CITY OF GLENDALE

AGENDA -- PLAN COMMISSION

Tuesday, August 6, 2019

Plan Commission Report

ARCHITECTURAL SITE PLAN

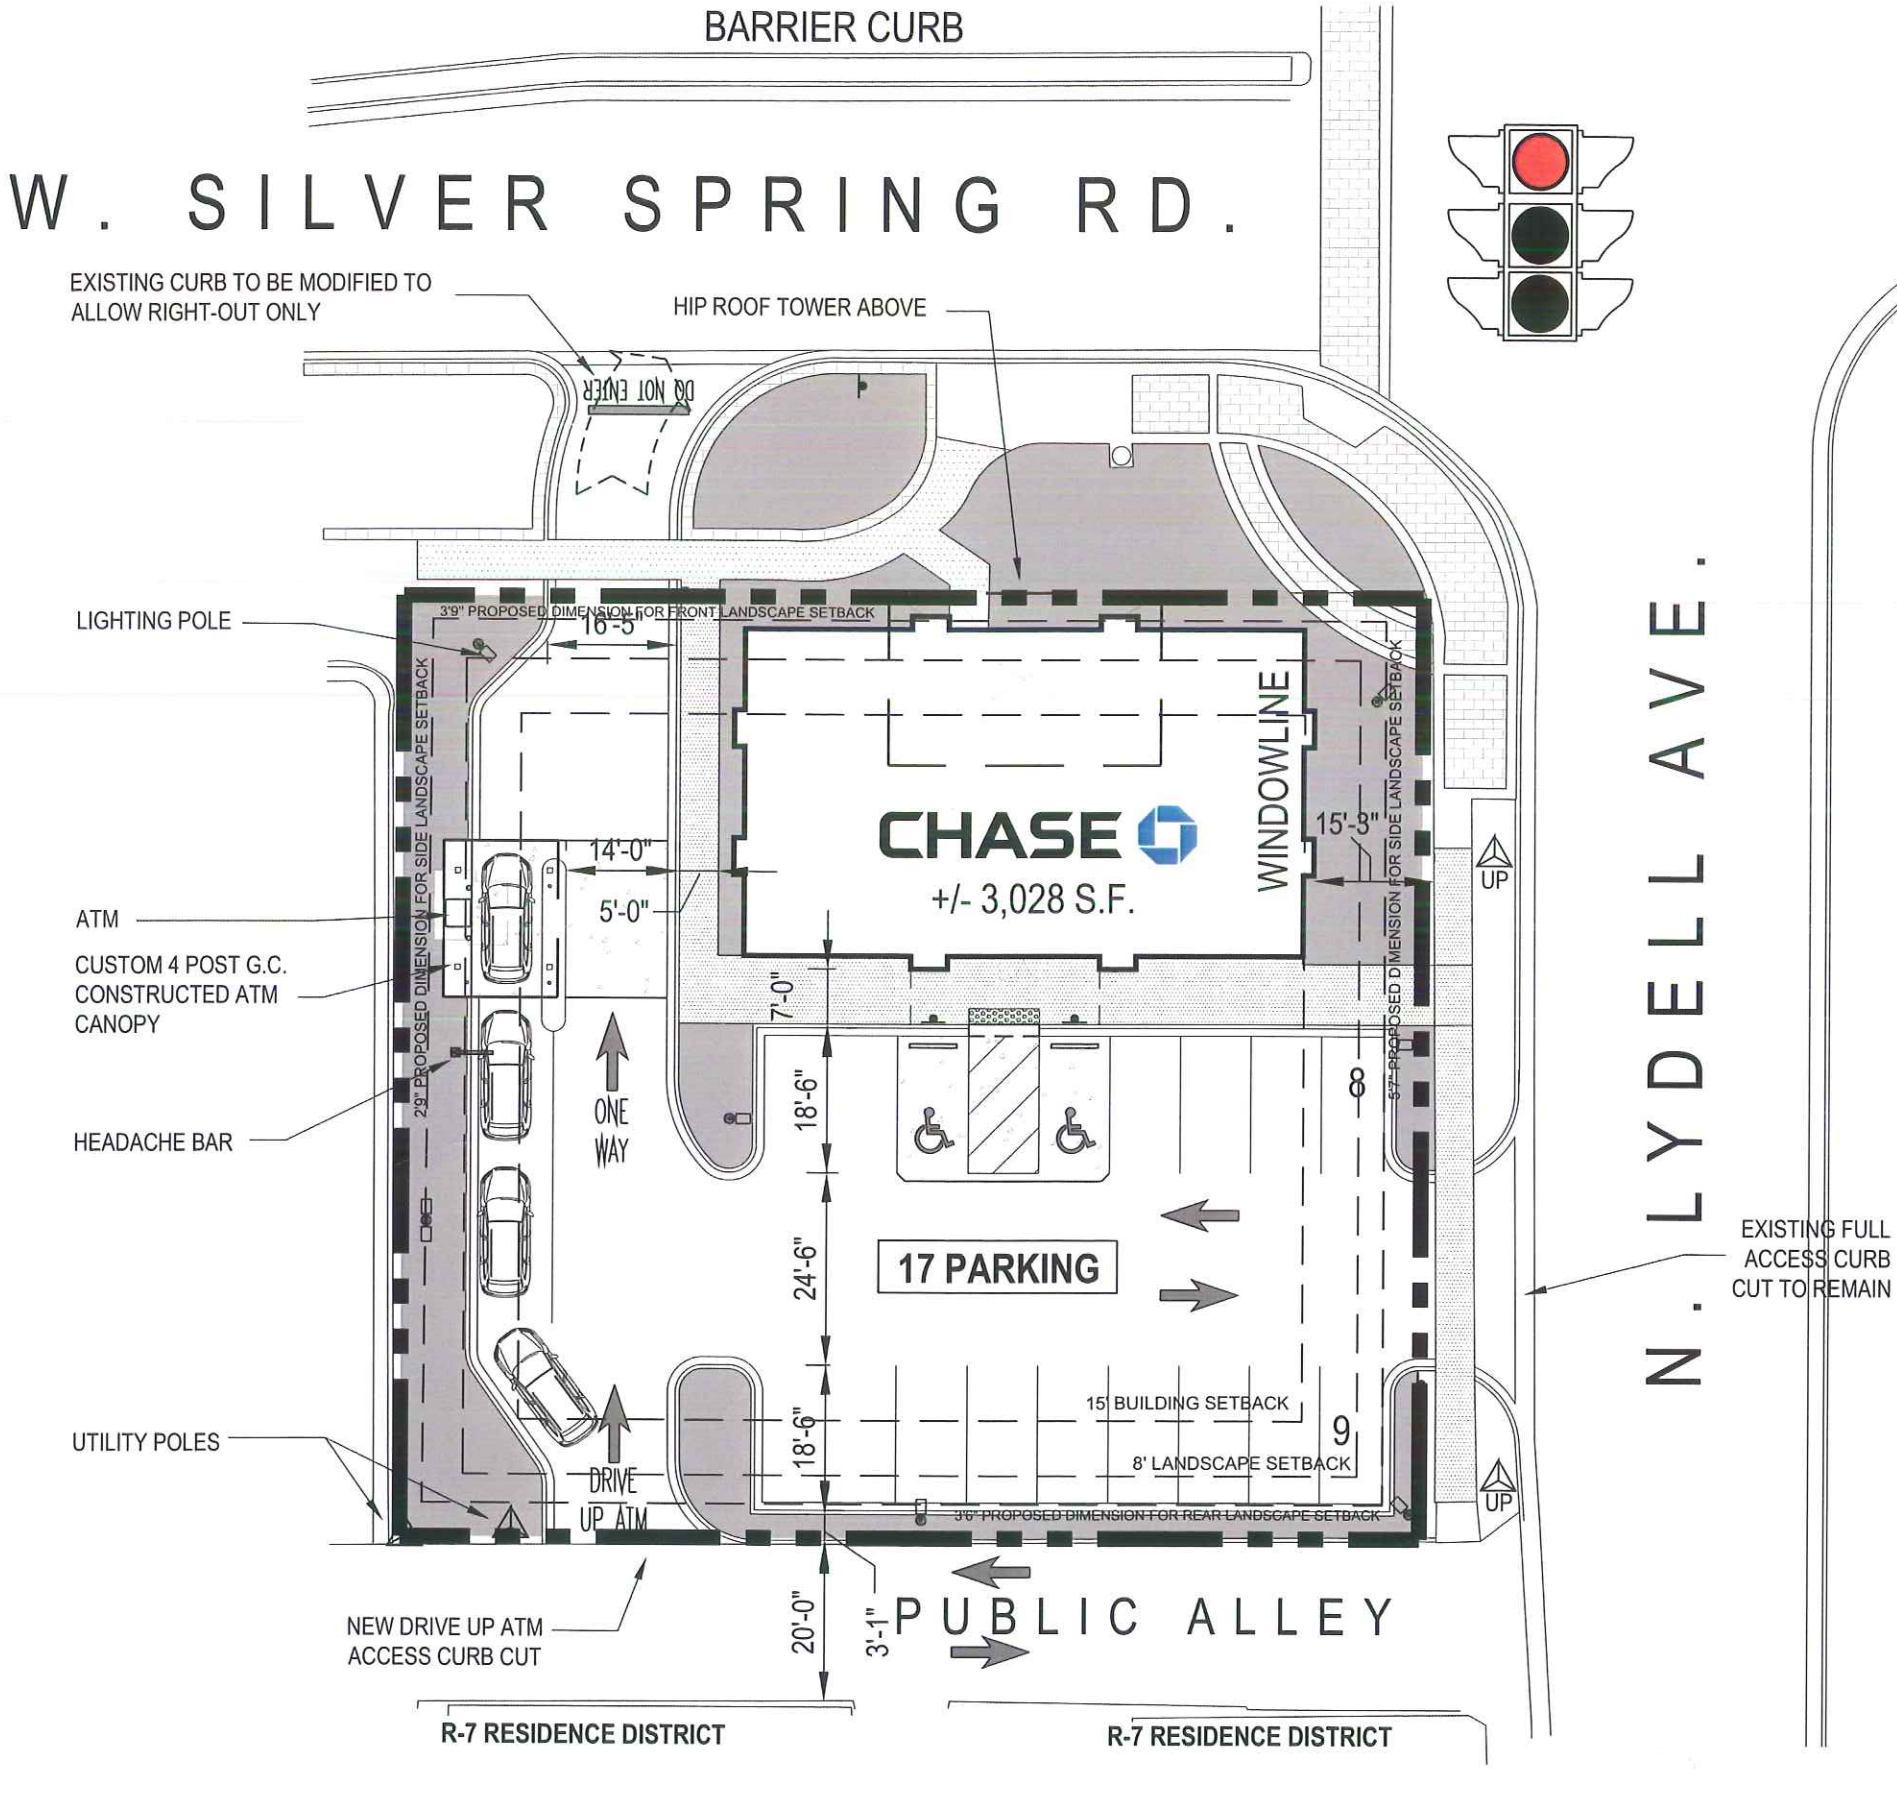
Seven light poles are proposed and there are also decorative wall mounted sconces at the north and south sides of the building, as well as lighting beneath the ATM canopy. The lighting plan requires further specification for review.

Contrary to several statements included in the submittal materials there are not any variances required in order for the proposed project to be approved by the plan Commission and proceed to construction.

Staff recommends that the Plan Commission grant approval of the architectural, site, landscaping, lighting, and signage plans, for CHASE Bank to construct the proposed bank, as well as approval of the proposed use and occupancy, per to the following requirements:

- 1) Signs require a Sign Permit per the City of Glendale Sign Code;
- 2) All landscaping and lighting features being maintained and replaced and/or replenished whenever necessary pursuant to tenant/owner lease responsibilities;
- 3) All modifications within the street right-of-way require review and permit(s) issued per the requirements of the City of Glendale Department of Public Works (Right-of-Way; Watermain Tap, Driveway, etc.)
- 4) All costs associated with approved and permitted modifications within the street right-
